Re: DPA Guidelines & OCP Compliance – Proposed Vidal Street Development, White Rock, BC

Re: ADP Comment Response Letter – Proposed Vidal Street Development, White Rock, BC

VIDAL STREET DEVELOPMENT
 VIDAL STREET, WHITE ROCK, B.C.

Figure 1 - Screenshot of survey showing locations of off-site Douglas-fir trees OS3-OS8.

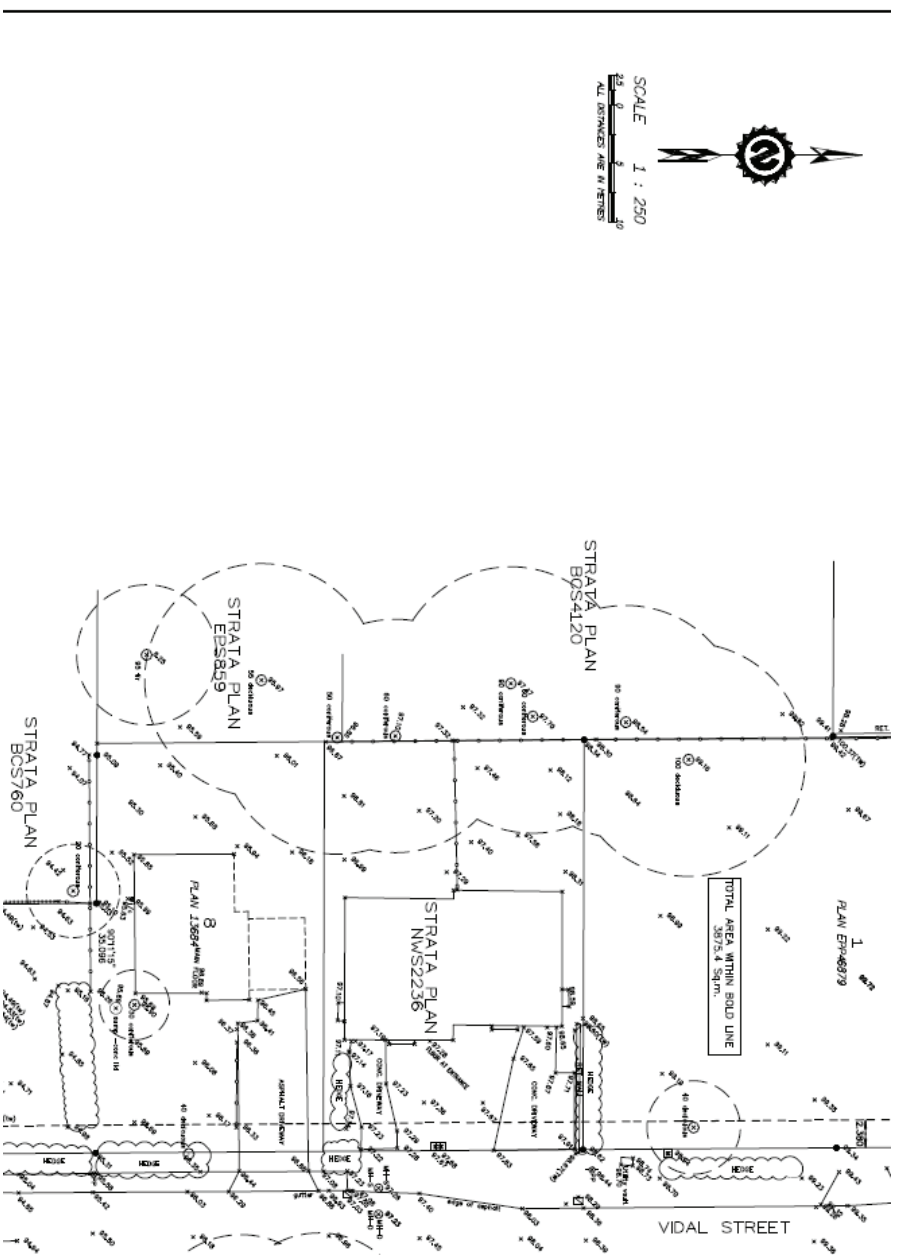
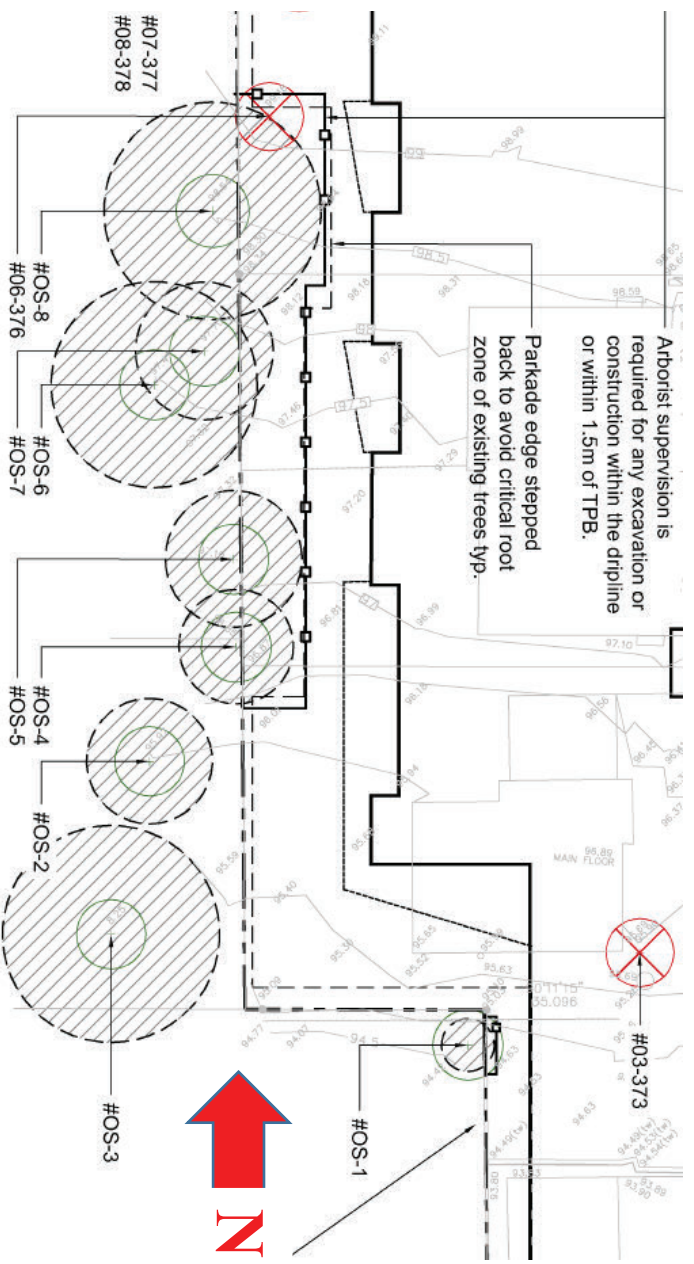
The legal survey was updated by Adam Fulkerson of Target Land Surveying Inc. on July 4, 2022 and shows the correct locations of offsite trees OS1-OS13 (Fig 1). VDZ+A project arborist, Glyn Romaine visited the site on July 8, 2022, to confirm the off-site tree locations matched those on the survey. The report and Tree Protection Plan were updated on July 11, 2022 using the latest survey. Douglas-fir trees OS3-OS8 are shown in their correct locations with root protection zones in the updated Tree Protection Plan (Fig 2).

Figure 2 - Screen shot of Tree Protection Plan with off-site Douglas fir trees OS3-OS8 in there correct locations based on the July 4, 2022 Survey.

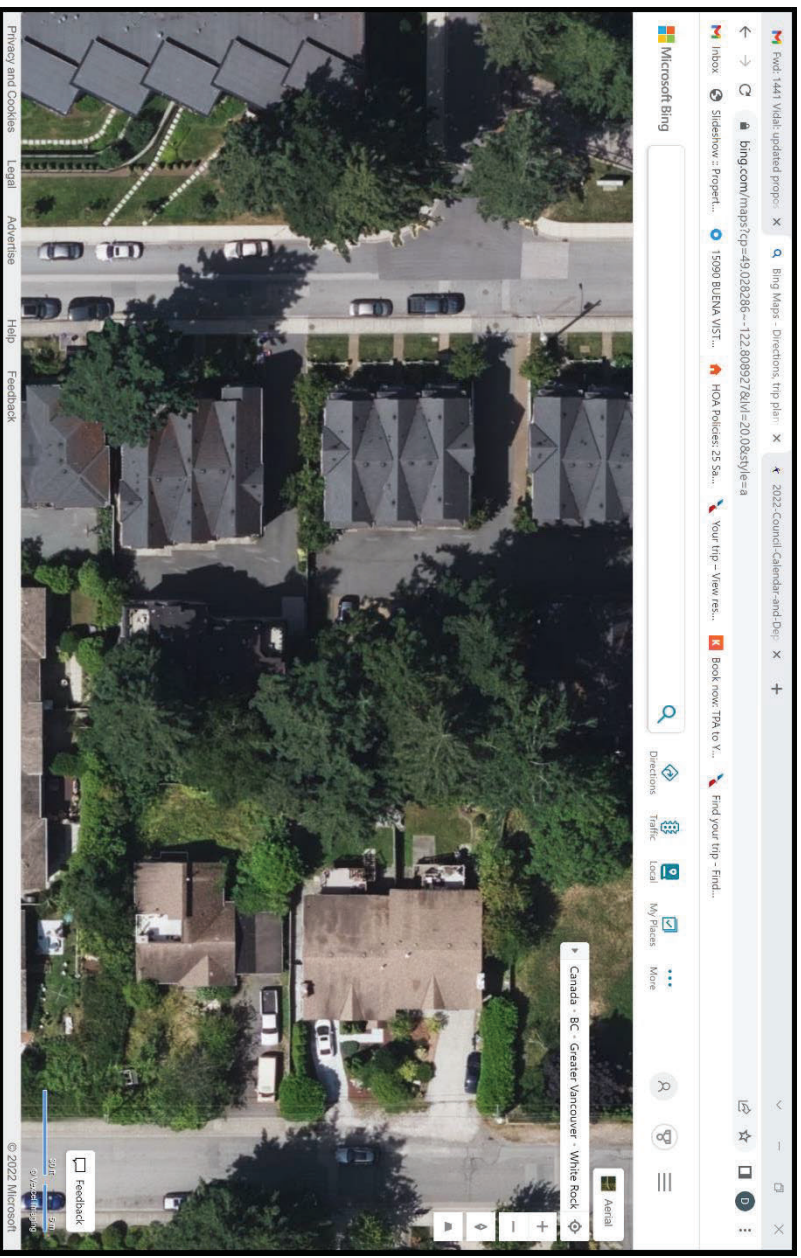
I am inserting a screenshot from Bing maps which shows the overhang onto the development lot all along the back fence of 1434 Everall.

These trees are protected trees under the White Rock Tree Protection Bylaw. Arborist response: Agree.

The critical root zone for each of these trees extends into the area shown as parkade in the drawings. Arborist response: Root mapping with radar has been done for these trees and the evidence supports using 6x trunk diameter at 1.4 m to determine the CRZ. The proposed parkade has been adjusted to accommodate the critical roots of these trees and the CRZ of these trees is shown on the TMP.
